Service Bulletin

File in Section: -
 Bulletin No.: 17-NA-255
 Date: August, 2017

Subject: Exhaust Fume Odor or Smell in Vehicle Cabin

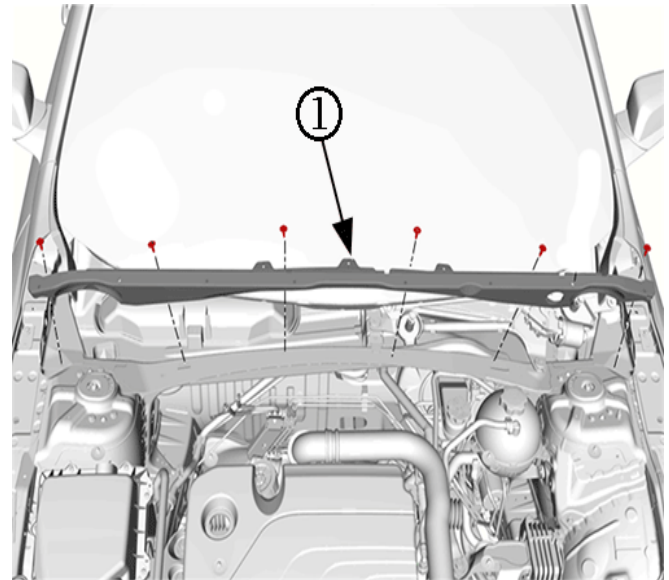
Involved Region or Country	North America and N.A. Export Regions
Condition	Some customers may comment on an exhaust fume odor or smell in the vehicle cabin.
Cause	<div style="text-align: center;">  <p>①</p> </div> <p style="text-align: right; font-size: small;">4847097</p> <p>The cause of the condition may be that the original torque specification noted for the underhood dash panel upper extension panel (1) installation, was too high. This over-torque may lead to cracking the plastic panel or creating a buckling and too large of a gap between the extension panel and the plenum.</p>
Correction	Verify the condition and inspect the underhood dash panel upper extension panel following the steps in the Service Procedure below.

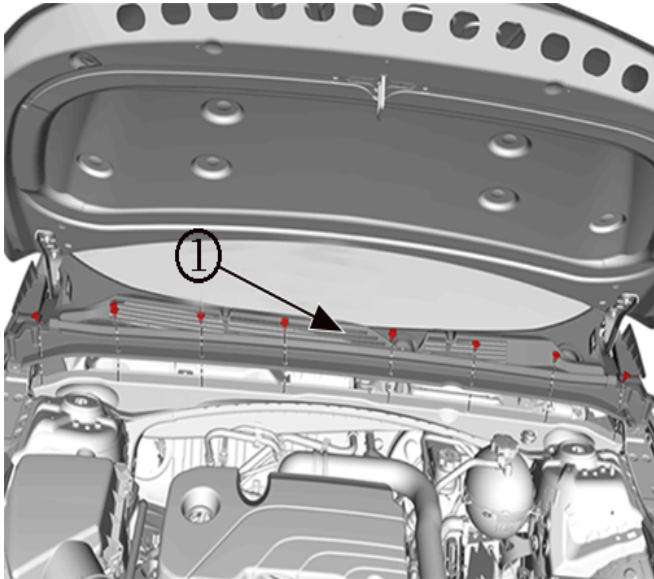
1. Remove the air inlet grille panel (1). Refer to *Air Inlet Grille Panel Replacement* in SI.
2. Visually inspect the underhood dash panel upper extension panel for cracks at the fastener locations. Also, between the fastener locations, check for buckles/gaps of over 2 mm between the extension panel and plenum.

Important: The torque specification currently published in SI is **INCORRECT**, and is in the process of being updated. The dash panel upper extension panel attachment bolts **should be tightened to a torque of 4.5 N•m (40 lb in)**.

- If the extension panel exhibits any damage or gaps, replace the panel (1). Refer to *Dash Panel Upper Extension Panel Extension Replacement* in SI.
- If no damage/gapping is found, reinstall the air inlet grille panel and refer to SI for further recommended diagnostics.
